**TOWN OF NEWBURGH  
PLANNING BOARD  
TECHNICAL REVIEW COMMENTS**

**PROJECT: 11 OLD BALMVILLE ROAD**  
**PROJECT NO.: 18-18**  
**PROJECT LOCATION: SECTION 84, BLOCK 5, LOT 26**  
**REVIEW DATE: 30 NOVEMBER 2018**  
**MEETING DATE: 6 DECEMBER 2018**  
**PROJECT REPRESENTATIVE: PITINGARO & DOETSCH**

**GRADING AND UTILITY PLAN**  
 FOR  
 11 OLD BALMVILLE ROAD  
 TOWN OF NEWBURGH, ORANGE COUNTY, NY

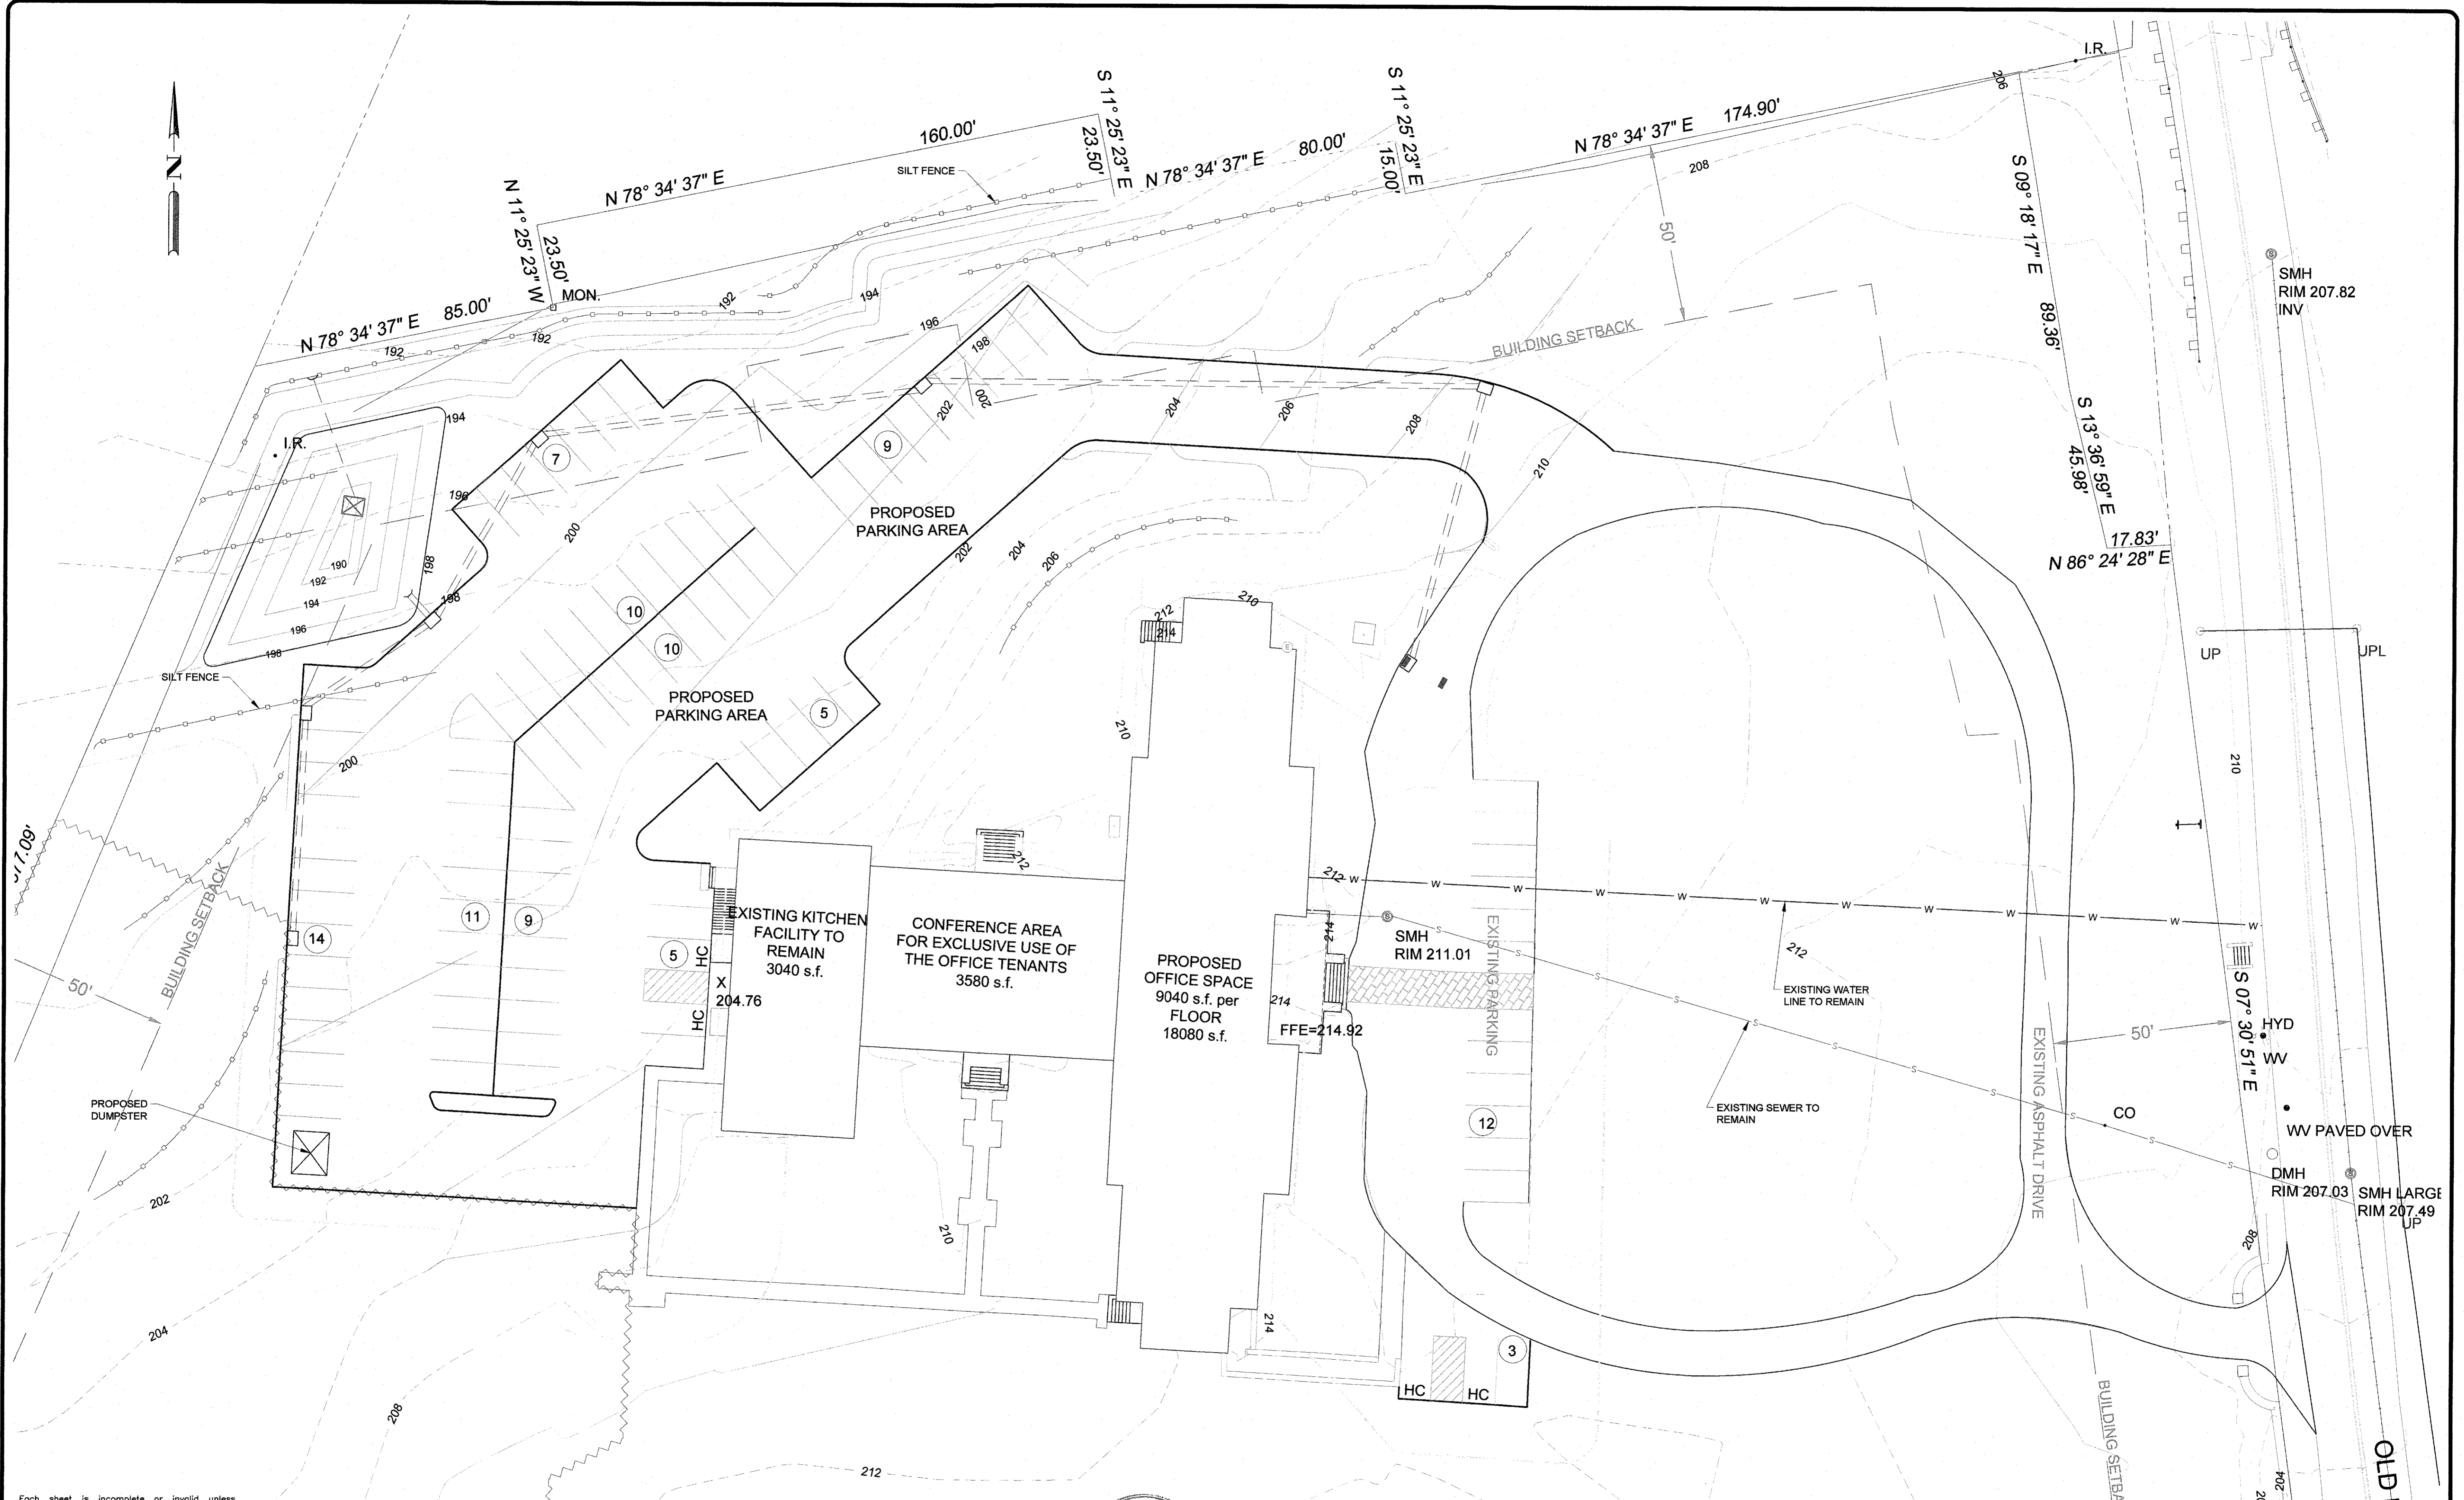
5. Dumpster enclosure should be addressed on the plans submitted.
6. Proposed catch basin #4 has a transposition error.
7. The Applicant's representative are requested to evaluate the discharge from the proposed catch basin #4 into the stormwater pond as a 6.6 foot elevation difference within the pond exists.

15. The stormwater model identifies a discharge from the detention pond facility at elevation 190. The lowest elevation on the site is elevation 192, with that contour running off the site. This should be evaluated by the Applicant's representative.

LANDSCAPING PLAN  
FOR  
11 OLD BALMVILLE ROAD  
TOWN OF NEWBURGH, ORANGE COUNTY, NY

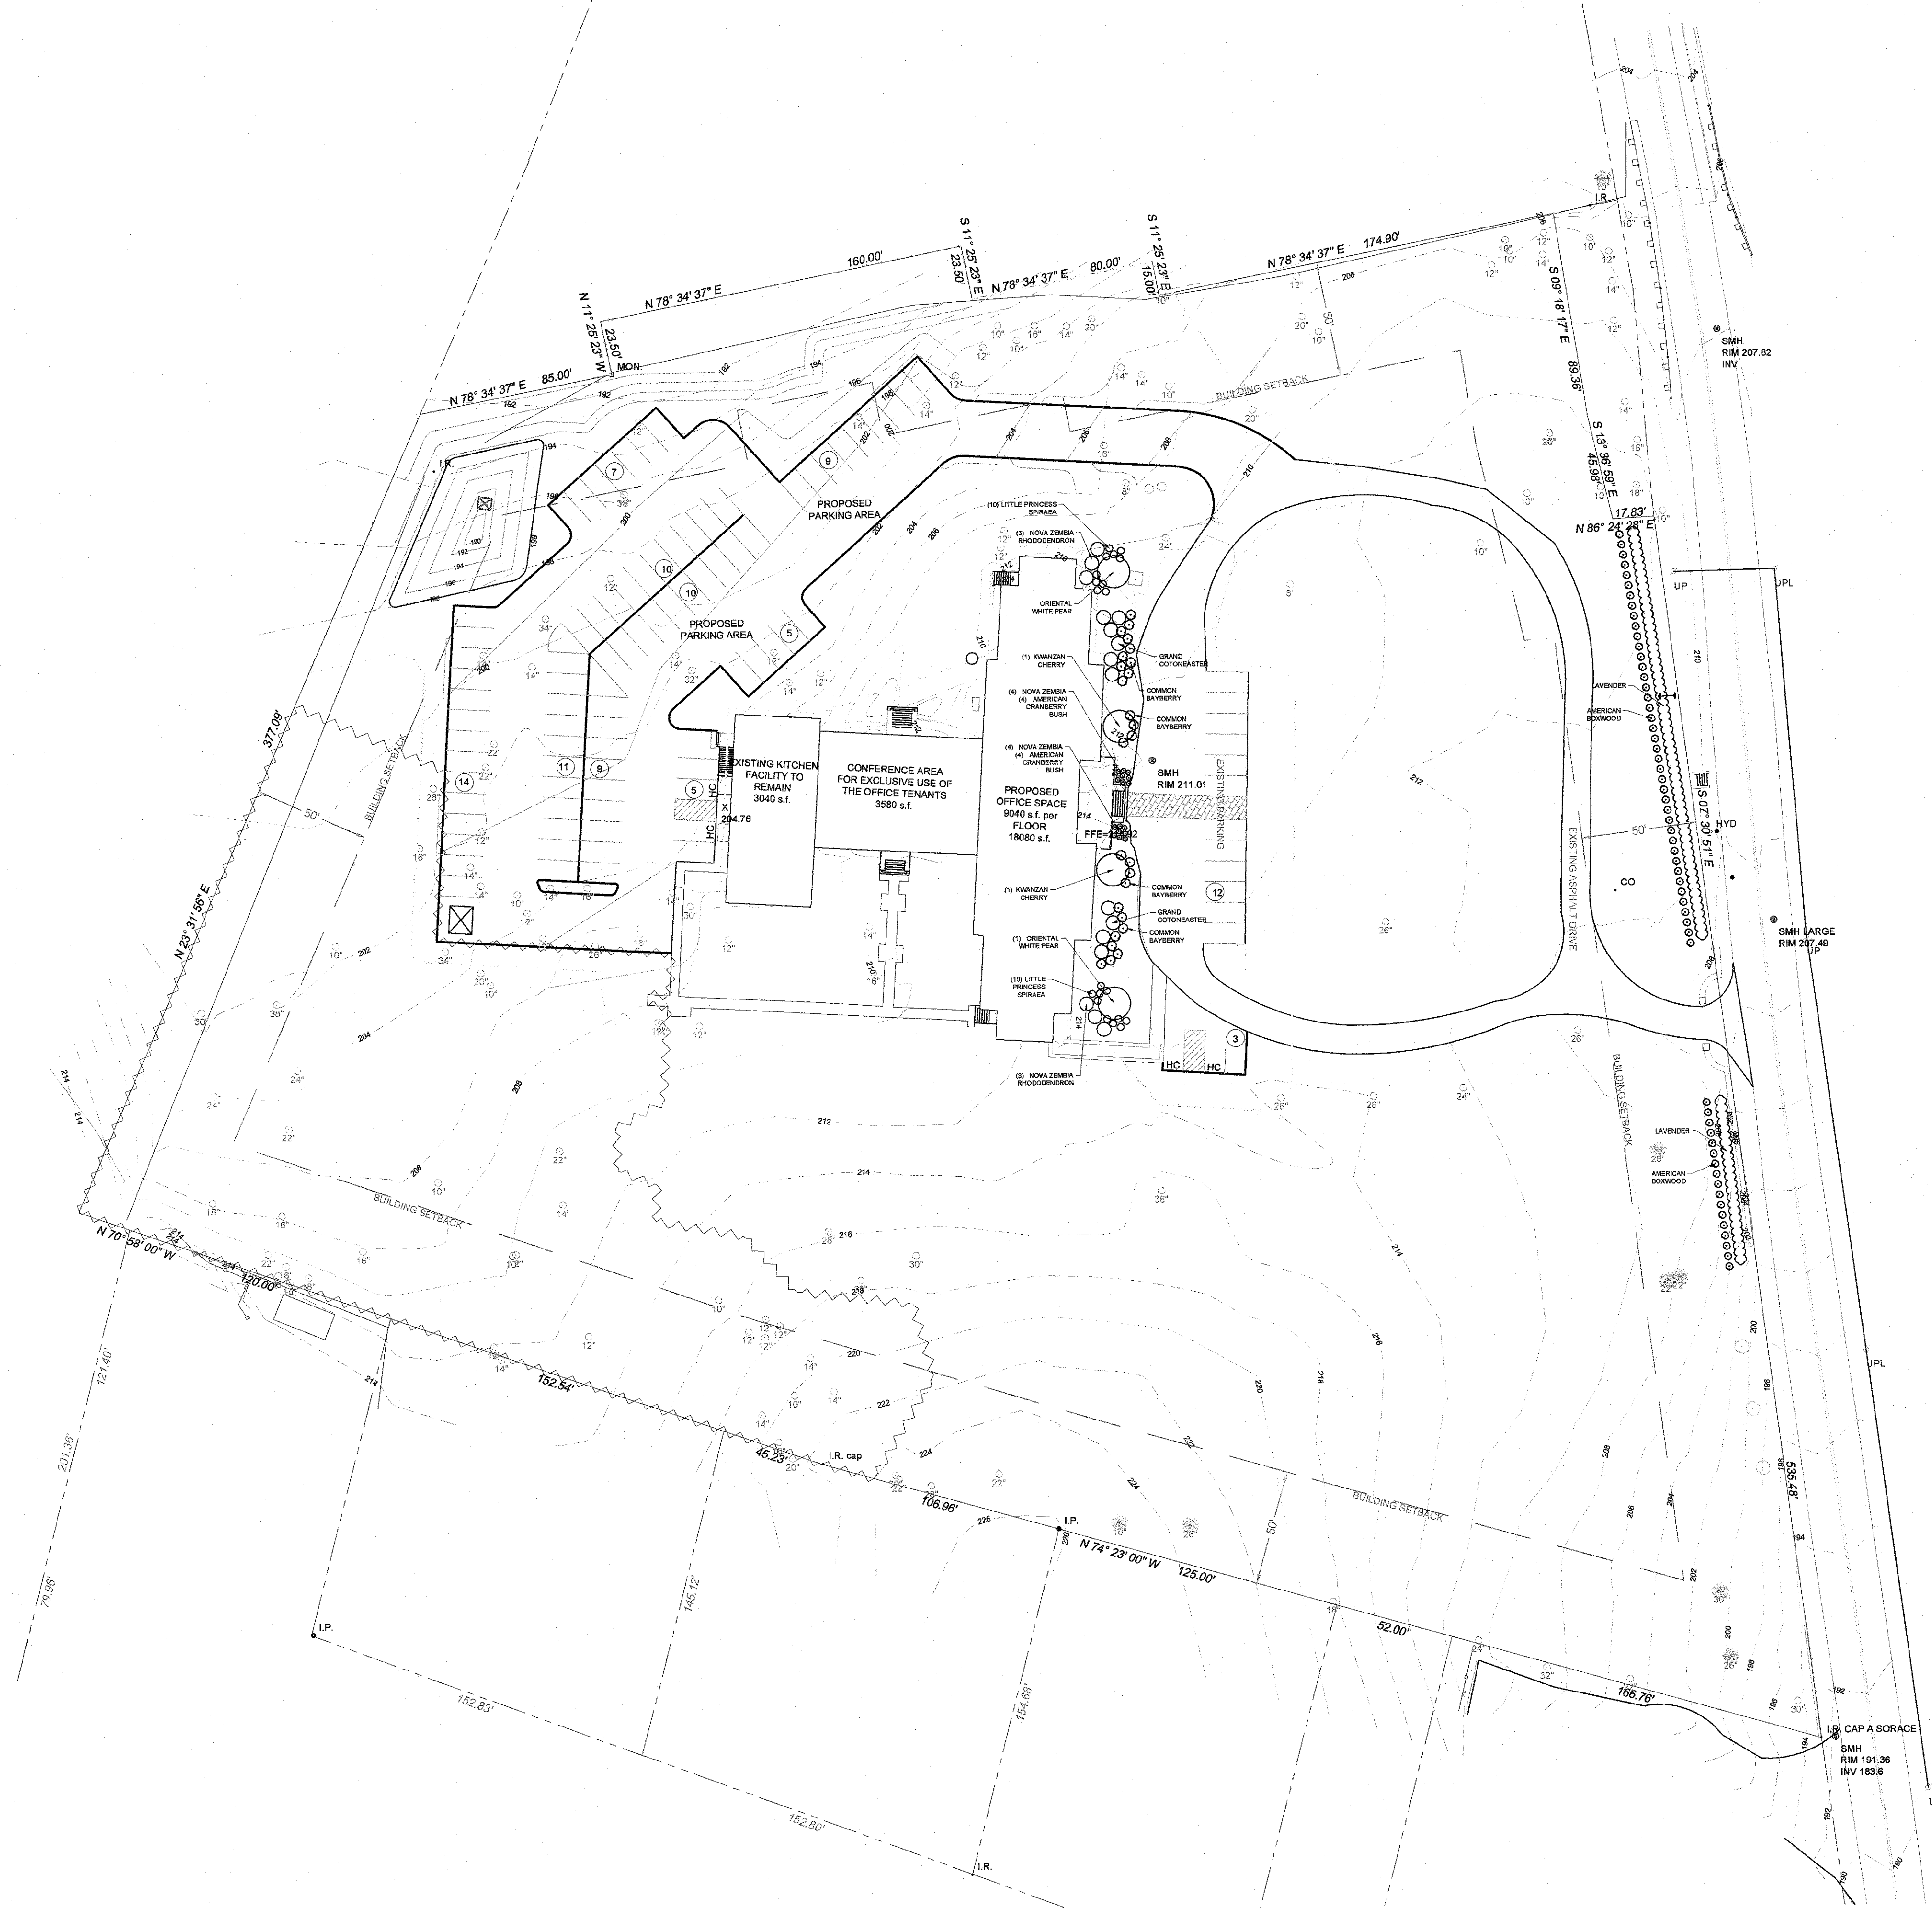
4. The Landscape Plan will be reviewed by the Planning Board's Landscape Architecture consultant, however the parking area as proposed is devoid of any landscaping. Landscaping should address the rear parking area, stormwater management facilities.

**BIORETENTION AREA DETAIL**

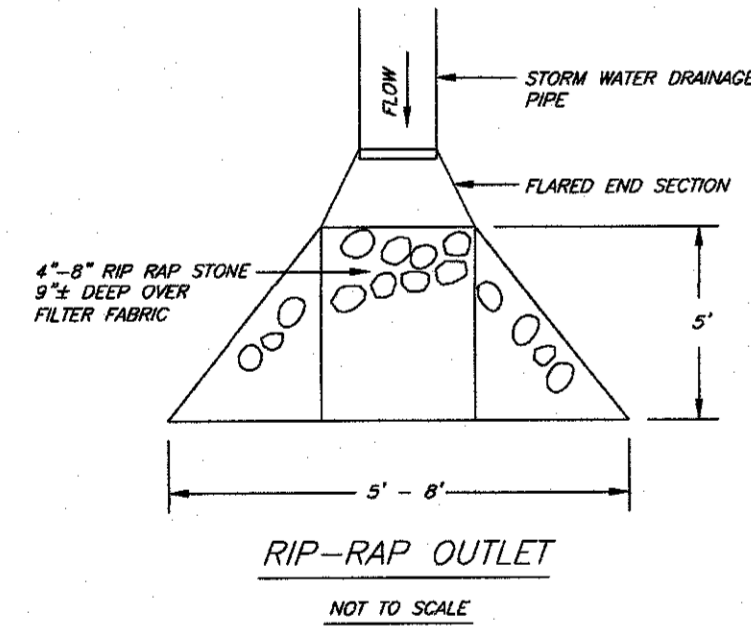
11. The SWPPP identifies the implementation of a bio-retention system and the plan sheets detail a bio-retention system. A bio-retention system is not depicted or included in the stormwater design plans. Bio-retention systems are designed as an infiltration practice which does not appear on the plans.
